International Code Council

**ICC 500-2020 edition
Public Input Agenda with
Committee Votes and Public Comments
based on input received
on 2014 edition of the
ICC 500 Standard**

**For February, 2020
2nd Meeting – Teleconference**

Matrix for ICC 500 proposals with Committee Votes or Public Comments

FIGURE 804.9.5(3)
ROLLING DOOR ASSEMBLIES

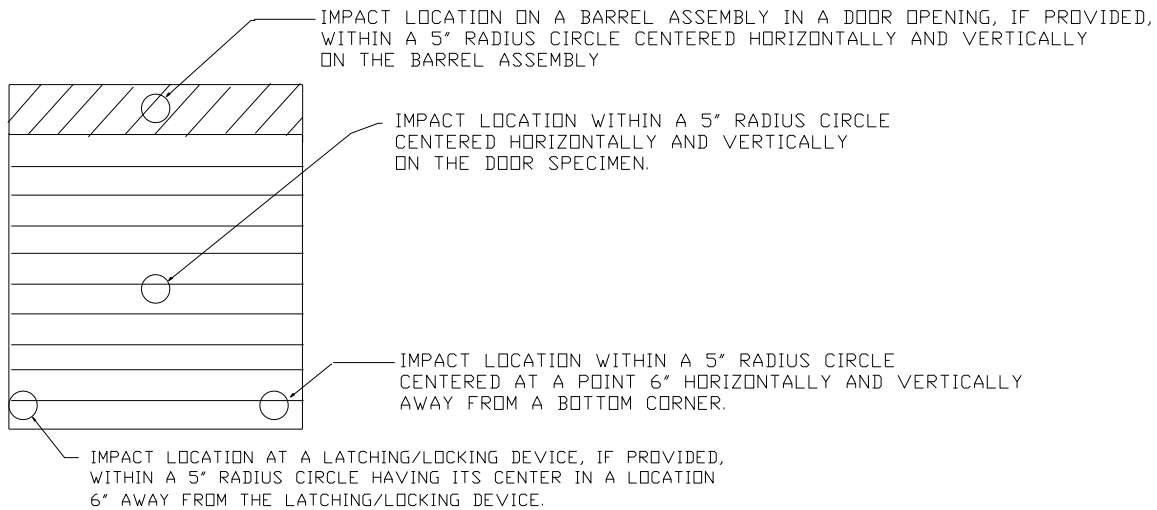
Reason: Clarify application of door impact provisions with respect to testing of rolling and sectional doors

FIGURE 804.9.5.2
ROLLING DOOR ASSEMBLIES

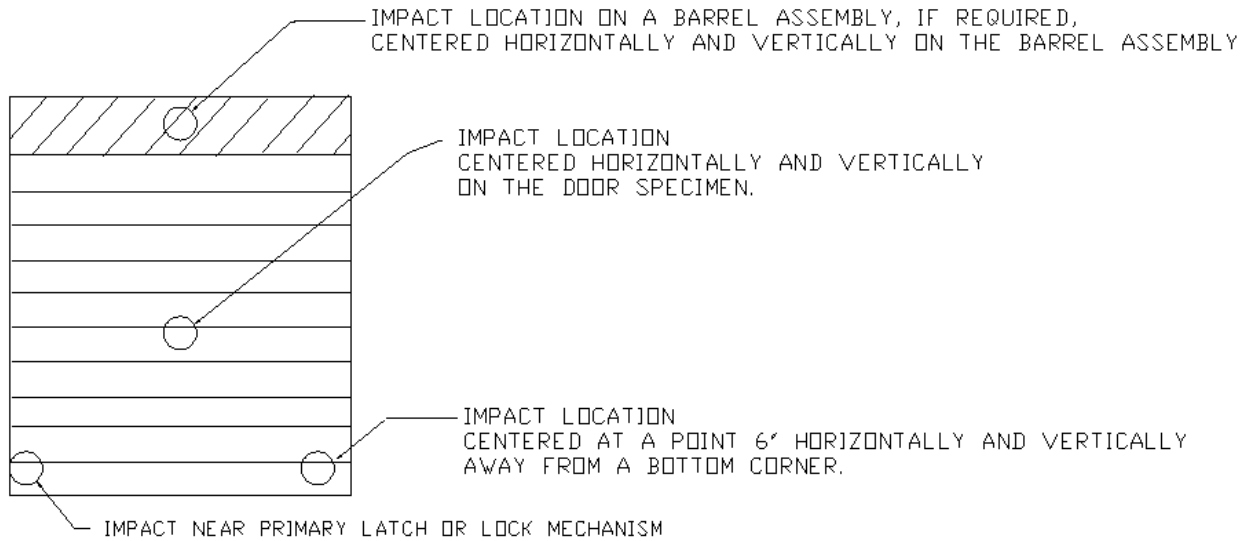
804.9.5.2 Rolling door assemblies. For rolling door assemblies, the door shall be impacted at the center of the door, at one bottom corner and within 6 inches (152.4 mm) of primary latches or operators, plus an additional impact centered on a barrel assembly as shown in Figure 804.9.5.2.

Exception: The barrel assembly is not subject to the additional impact where the entire barrel assembly is protected by the shelter envelope.

FIGURE 804.9.5.3
SECTIONAL DOOR ASSEMBLIES

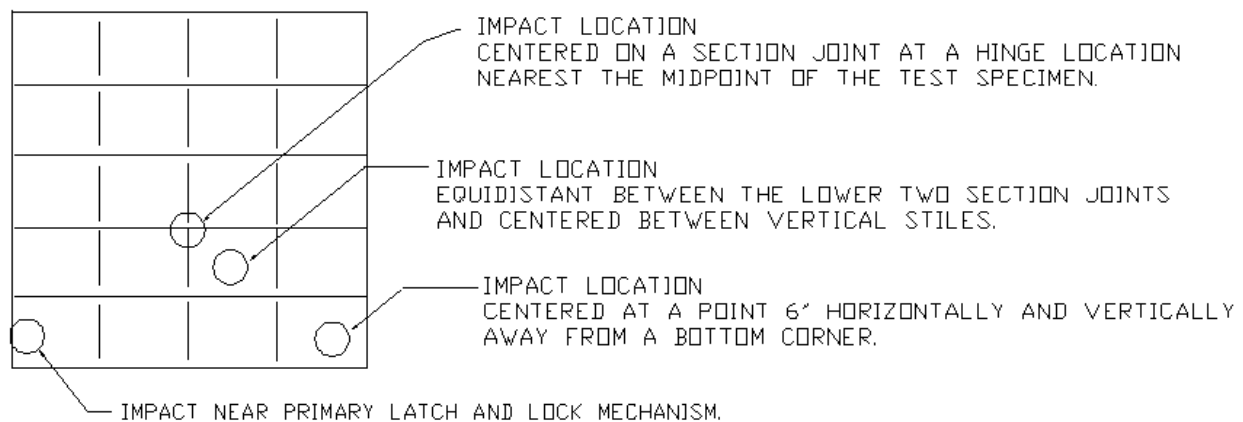
804.9.5.3 Sectional door assemblies. For sectional door assemblies, the door shall be impacted at a sectional joint nearing to the center of the door, within the lower two section joints and centered between two vertical stiles, at one bottom corner, and within 6 inches (152 mm) of the primary latches or operators as shown in Figure 804.9.5.3.

FIGURE 804.9.7.2
DOORS SUBJECT TO REBOUND IMPACT

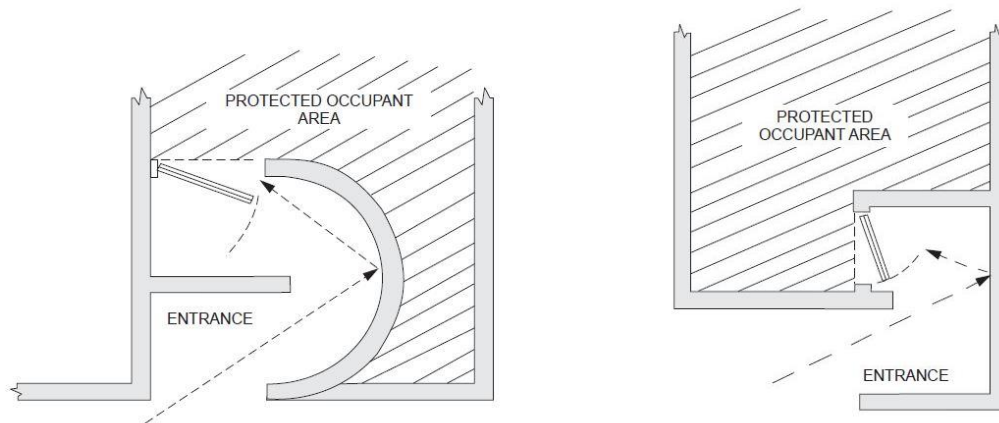
804.9.7.2 Door subject to rebound impact. Where the alcove or baffled entry system prevents a first impact of the design missile on the door but the door is subject to a rebounded impact of the design missile after it has impacted one surface meeting the requirements of Section 306.2 possible (~~see as detailed in~~ Figure 804.9.7.2), then a door assembly shall meet the wind load requirements of Section 304 and the debris impact requirements of Section 305 except that the missile shall be, at a minimum, a 9-pound sawn lumber 2 by 4 traveling at 50 feet per second (15.2 m/s). Entry systems having doors that are protected from the initial and first rebounded impacts of debris shall comply with the requirements of Section 804.9.7.1.

Reason: The way figures are referenced is not consistent and does not make the figure part of the requirement. Using “as detailed in” or “as shown in” would be consistent with the figure references of impact location in 804.9. In Items 1, 2 and 3 of Section 804.9.7, “Examples of this type of system are shown in Figure....” is not needed. As written it is editorials information, not a requirement; and the figures are referenced in each of the referenced sections.

FIGURE 804.9.7.3
DOORS SUBJECT TO FIRST IMPACT

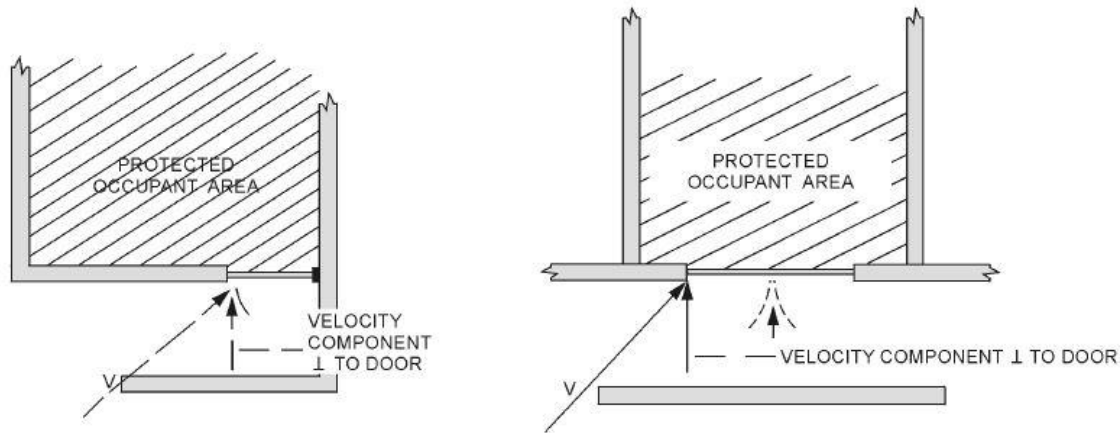
804.9.7.3 Door subject to first impact. If a first-strike angle missile impact on the door is possible (~~see as detailed in~~ Figure 804.9.7.3), then the door is deemed suitable if the door assembly meets the wind load requirements of Section 304 and the door assembly meets one of the following debris impact criteria:
